**OFFICE OF DESIGN POLICY & SUPPORT
INTERDEPARTMENTAL CORRESPONDENCE**

SUBJECT APPROVED CONCEPT REPORT

PROJECT CONCEPT REPORT

The city of Decatur SRTS with improvements at Carl G. Renfroe Middle, Clairemont Elementary, Glennwood Academy, Oakhurst Elementary, and Winnona Park Elementary school areas.

STATE OF GEORGIA
 DEPARTMENT OF TRANSPORTATION
 OFFICE: DISTRICT 7 DESIGN
MAINLINE PLAN
 GLENWOOD ACADEMY

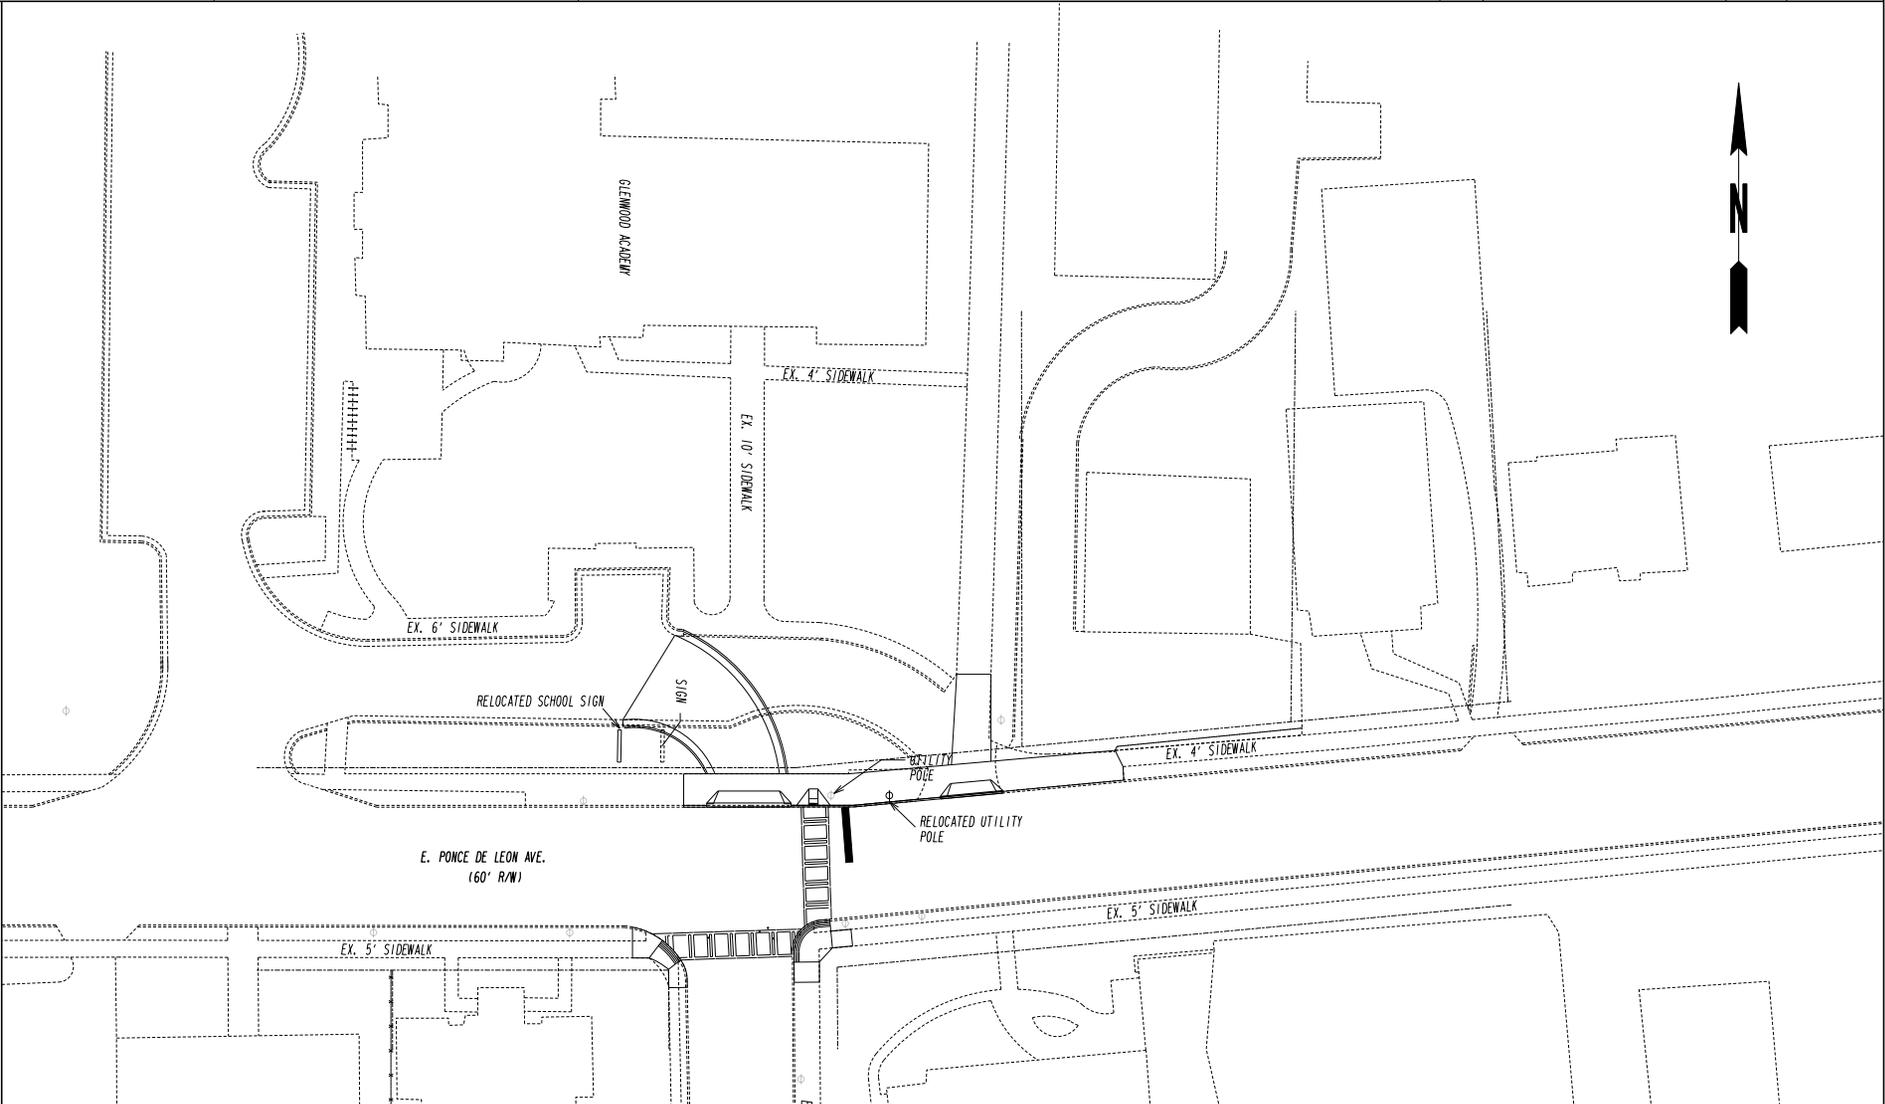
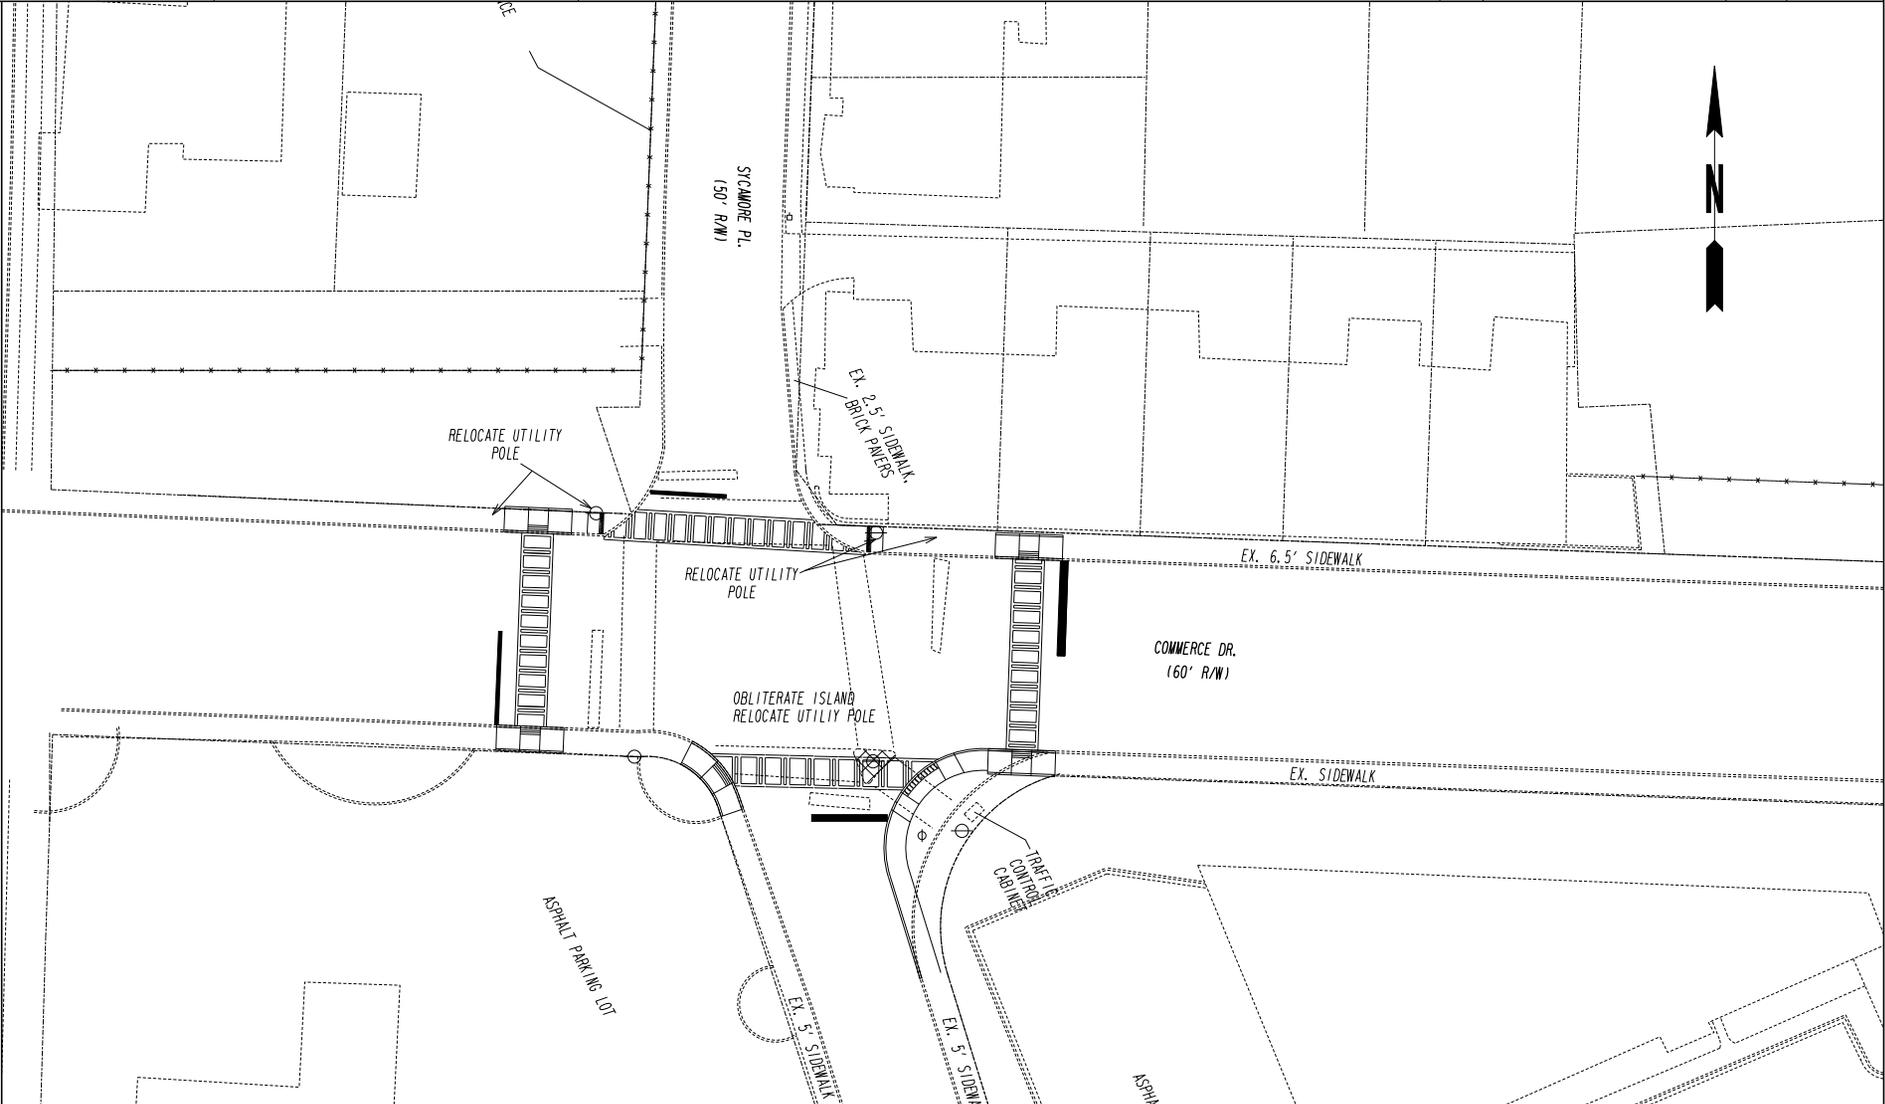
On your layout sheets there are flags for utility pole relocations. Also in the Project Activities, you list GDOT as being responsible for these tasks. These types of projects don't have utility cost with them.

Darrell, you are correct. If Georgia Power Poles are in the Right –of –Way they are not reimbursable for relocation on the SRTS projects.

I'm still working with D7 Utilities to get a response on the utility poles. We are playing phone tag with GA Power to verify our assumption that since these poles are in the ROW then GA Power will not be reimbursed to move them.
